Riverfront Phase IIB Fort Wayne, IN

ADDENDUM #1

October 7, 2024

ADDENDUM NO. 1

NOTE: This is not a re-issuance or a new sheet, it is simply red-line mark-ups to try and help provide further clarification for Bid Item's #1 & #4 where their scopes of work start and stop for backfilling.

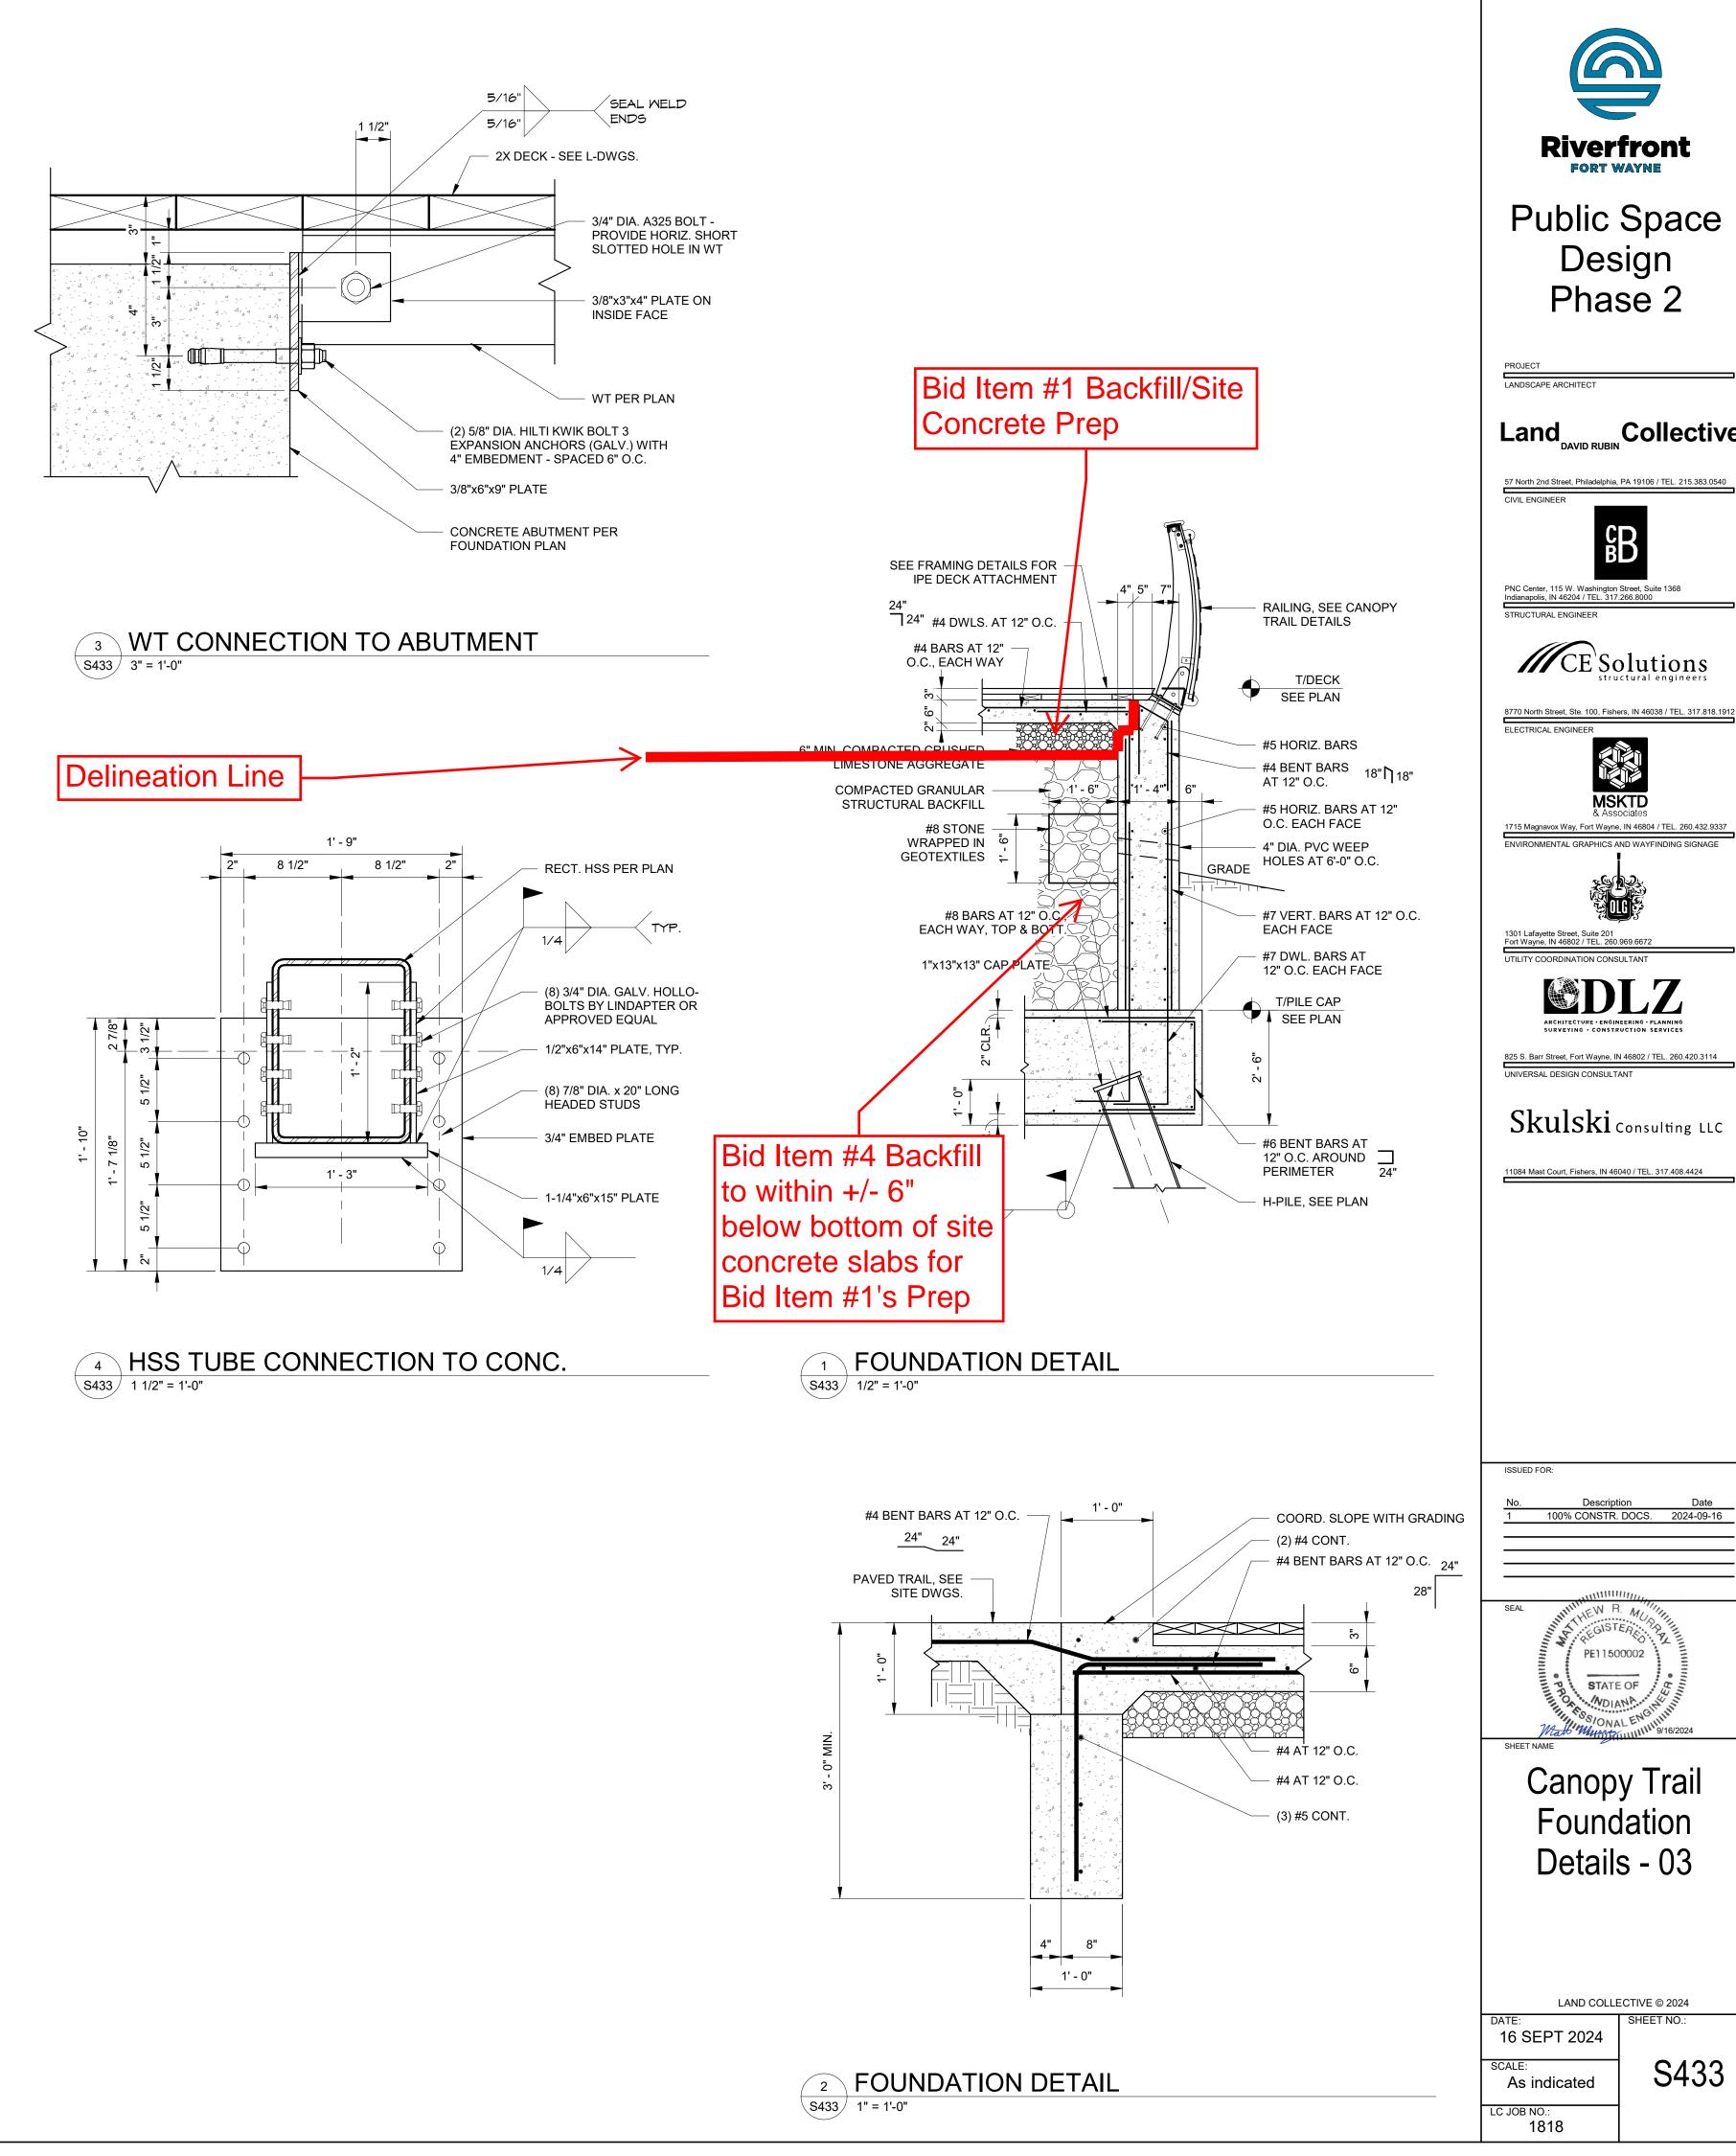
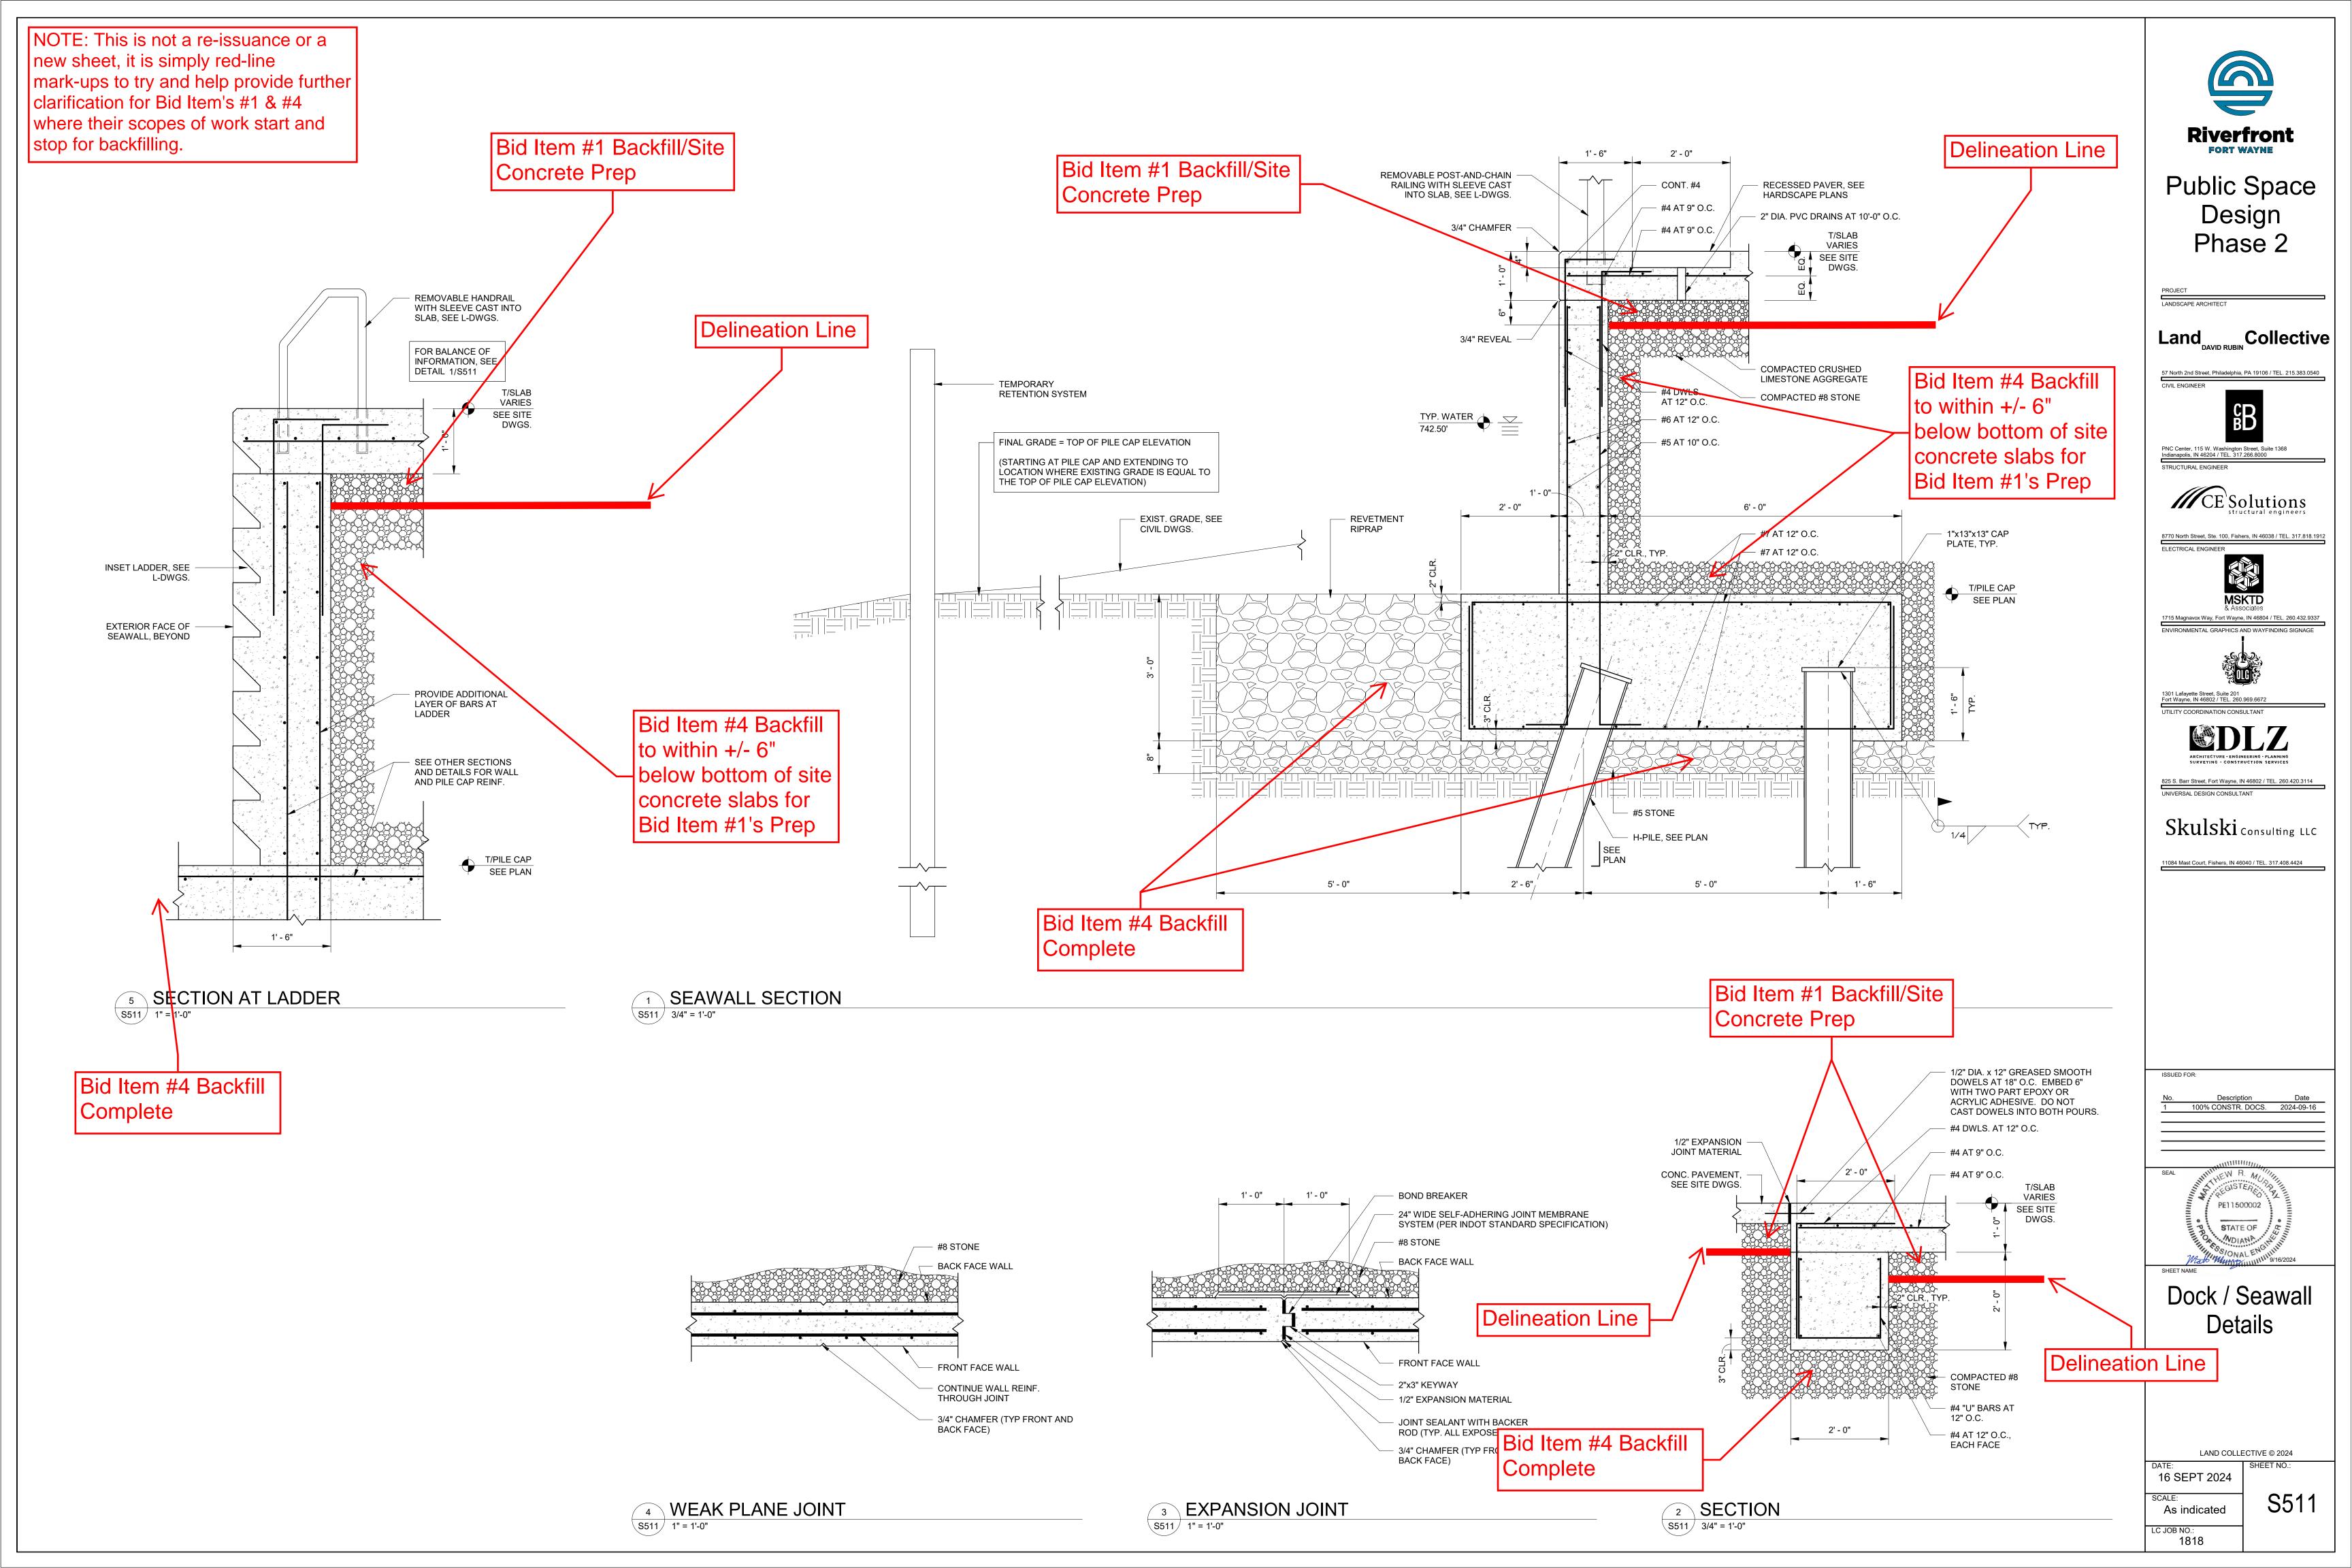
NOTE: This is not a re-issuance or a new sheet, it is simply red-line mark-ups to try and help provide further clarification for Bid Item's #1 & #4 where their scopes of work start and stop for backfilling.
